MEMORANDUM

TO: District of Columbia Zoning Commission
FROM: Jennifer Steingasser, Deputy Director *JS*
DATE: February 15, 2008
SUBJECT: Final Report for Z.C. 07-21
Consolidated Planned Unit Development at 2213 M Street, N.W.

FEB 05 2008
 A.16
 ELEVATION - NORTH
 © CONCRETE WALL

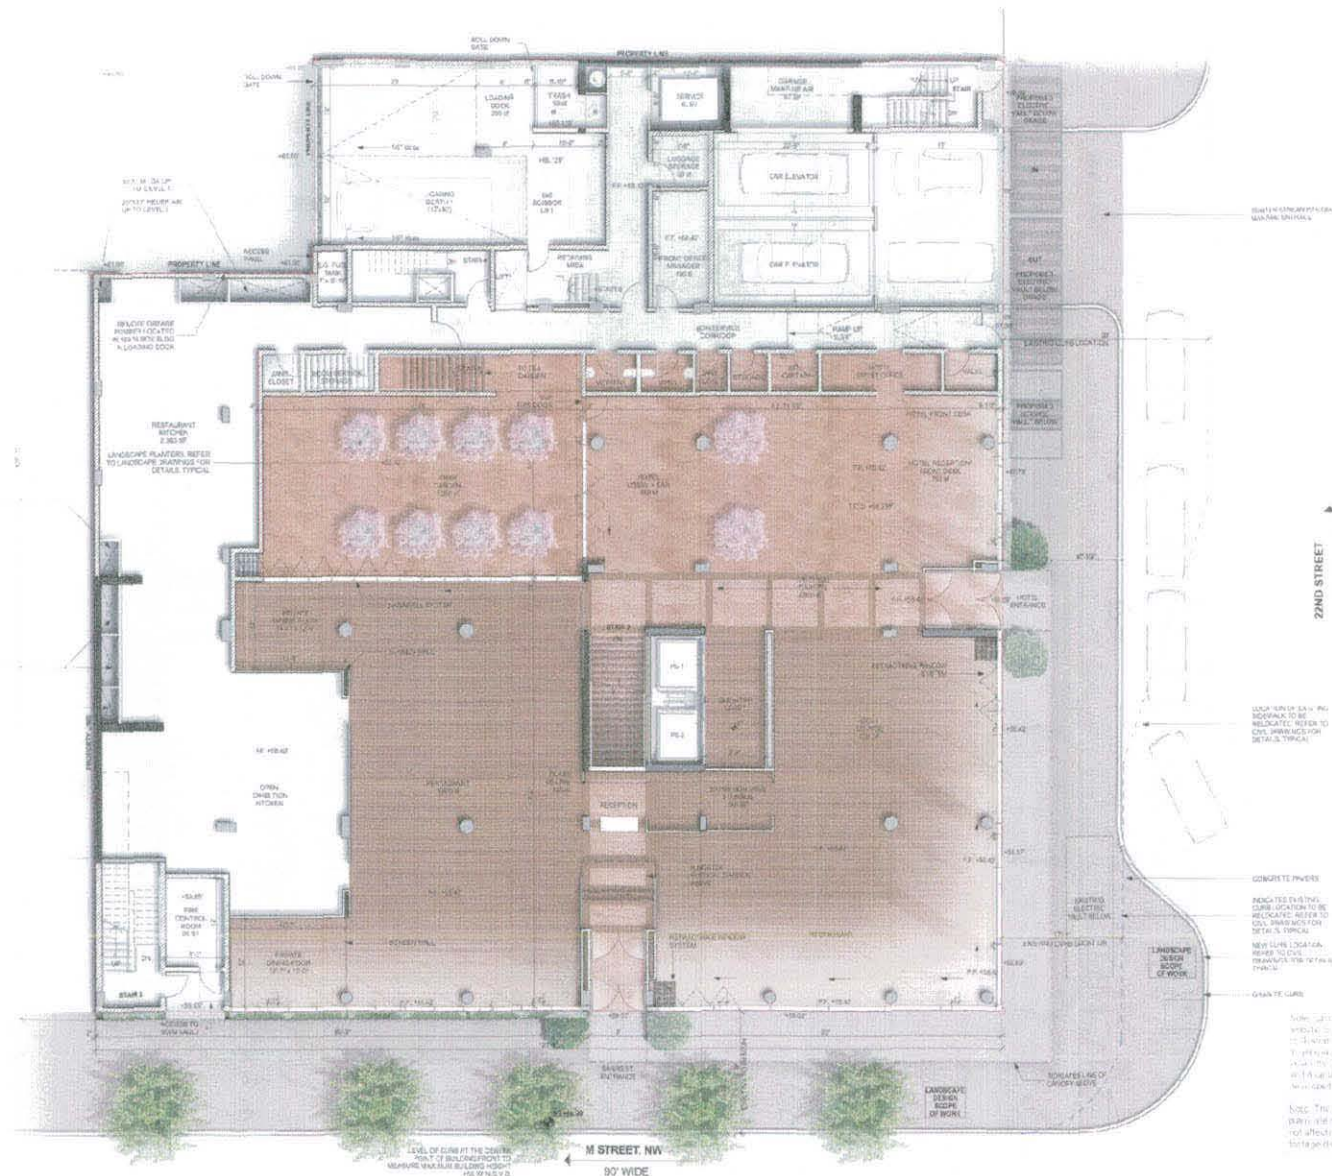
OP had also asked the applicant to re-consider its proposed facing for the western and northern building walls and roof structure enclosures. Inclusive of the roof enclosure, they will rise approximately ninety feet higher than the northern and western-adjacent four story structures. The applicant proposed they be painted cementitious surfaces. OP did not find the materials and finishing to be suitable for PUD walls that will have prominent exposure. The applicant submitted a revised design to OP on February 14, 2008. This is attached to OP's report. OP did not have time to review the proposal in detail. It appears that the design has been improved by scoring the exposed wall and distinguishing the color of the roof structure enclosure from the color of the side wall. ***OP is concerned that, despite the design revisions, both the side wall and side of the roof structure remain faced with a painted cementitious surface.***

- In addition to the revised design of the exposed portions of the northern and western walls of the building and roof structure that is attached to this report, prior to proposed action the applicant shall address OP's concerns about the durability and appearance of the proposed cementitious surfaces by submitting information that compares the performance and appearance of this material to materials such as stone, glass, and metal.
